URGENT: FIELD SAFETY NOTICE – MDS-24-5154-B

4Fr Single Lumen PowerPICC (SOLO and non-SOLO versions)

Type of Action: Product Removal

Figure 2: Image of the PowerPICC Taper Region

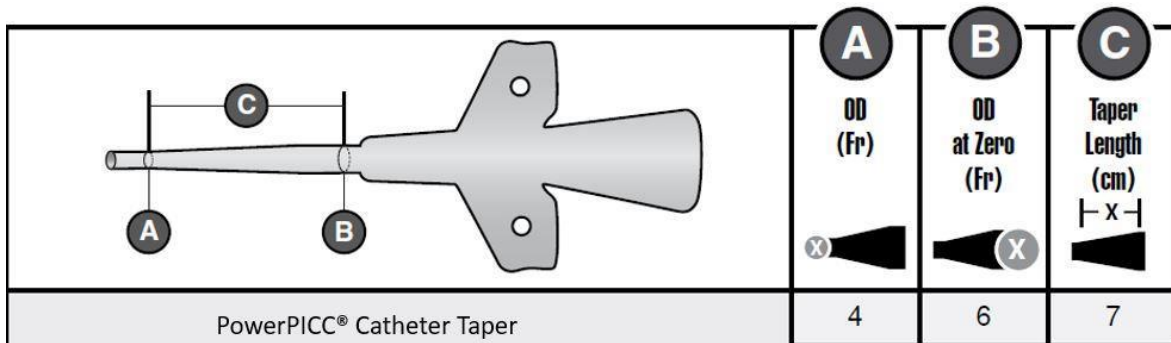
BD PICCs have a reverse taper which increases in diameter near the 0 marking on the device.

- Fully inserting the PICC device into the patient, as close as possible to the zero mark (position B in Figure 2), including the kink-resistant, reverse tapered region at the insertion site, is associated with lower leakage rates. To determine corresponding compression style size see figure 2, which shows that for the 4 Fr PICC, the size will be between 4 to 6 Fr, depending on the position of the securement device relative to the taper.

- BD strongly recommends the use of adhesive backed securement systems (e.g. Statlock) instead of 'compression style' securement systems.
- Securement systems should be appropriately sized to accommodate the increase in diameter of the catheter in the taper region.
